CONSTRUCTION STORMWATER GENERAL PERMIT INSPECTION REPORT

State of Washington Department of Ecology

The Electron Hydro LLC Intake project is covered under the State of Washington's Construction Stormwater General Permit (CSWGP). The CSWGP is a National Pollutant Discharge Elimination System (NPDES) and a State Waste Discharge permit for discharge of construction-related stormwater. Carol Serdar had previously been to the site a few years' prior, during the JARPA review for the then proposed re-construction of the barrier dam and intake structure; and on 11 August 2020 in response to ERTS699710; and 17 August 2020 for a CSWGP compliance inspection.

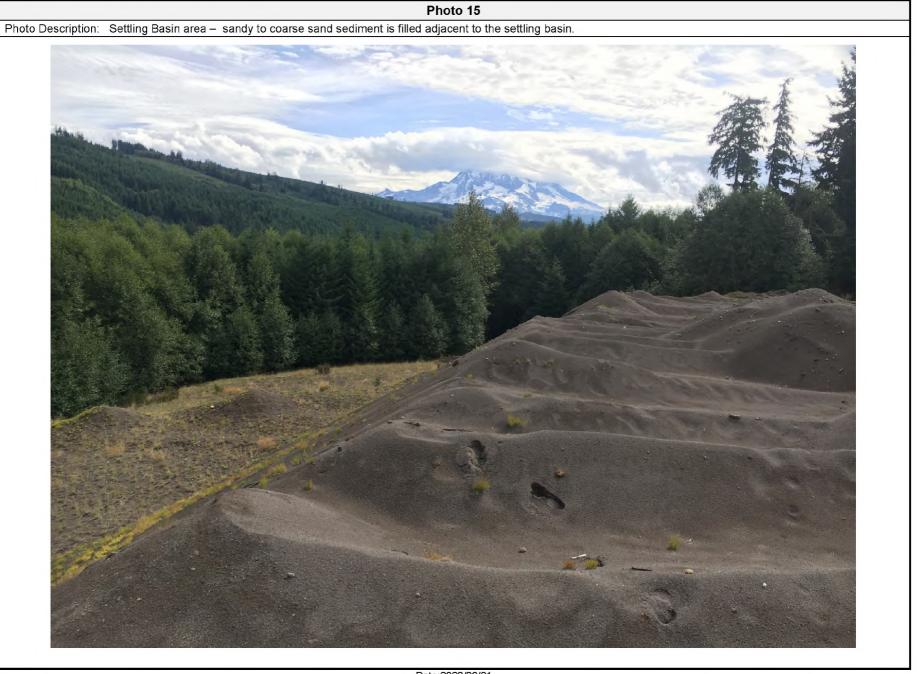
Photo Description: Settling Basin area – cobbles had dropped out of suspension; side wall needs repair, note the slumping of top of sidewall.

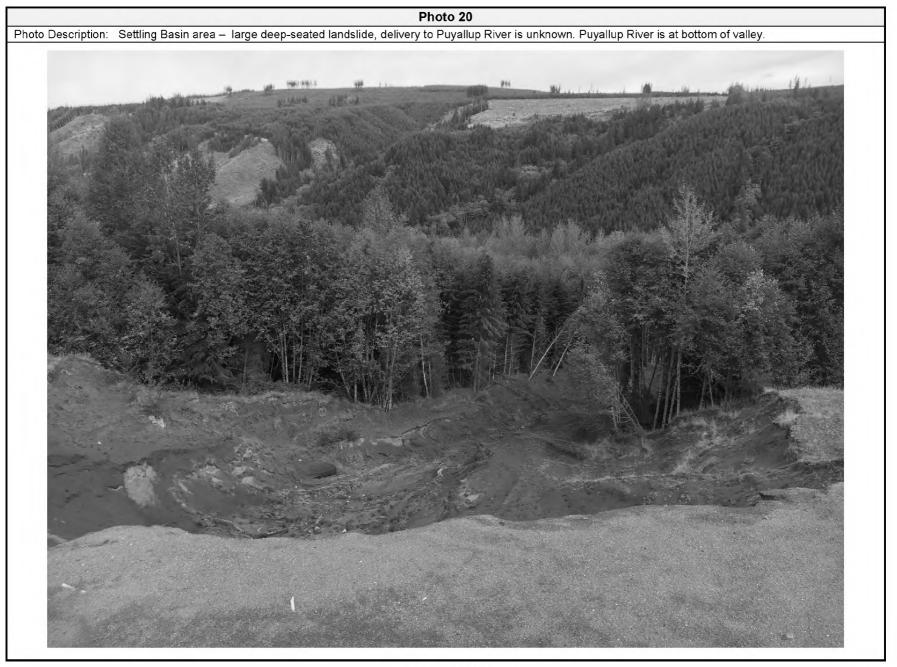
Photo Description: Settling Basin area – Sandy to coarse sand sediment is filled adjacent to the settling basin. Large deep-seated landslide, occurred during storms of Jan-Feb 2020; unsure if landslide delivered sediment to the Puyallup River. Carol will return to walk landslide deposit runout.

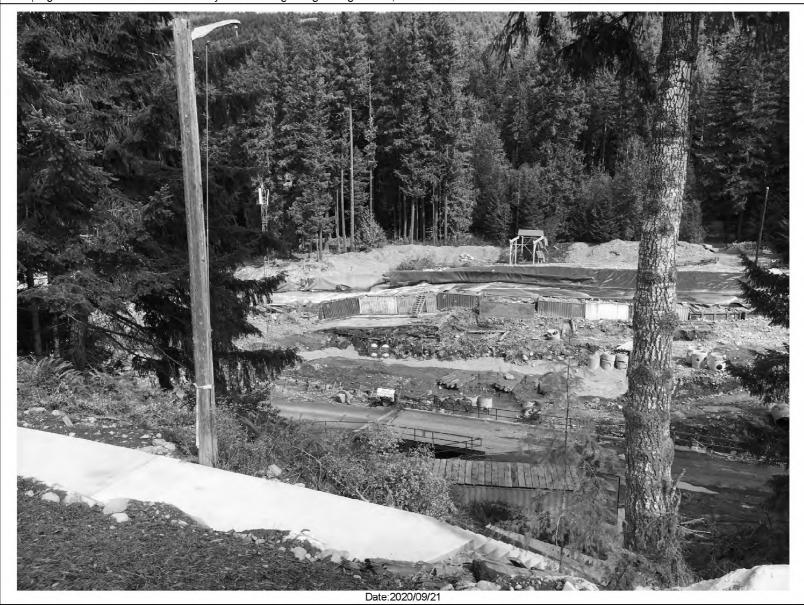
Photo Description: Intake Structure Construction area – concrete stairs have been poured and area stabilized; note by-pass channel in black liner, some slumping of soil below the black liner may be occurring along the right bank, downstream of fish ladder entrance.
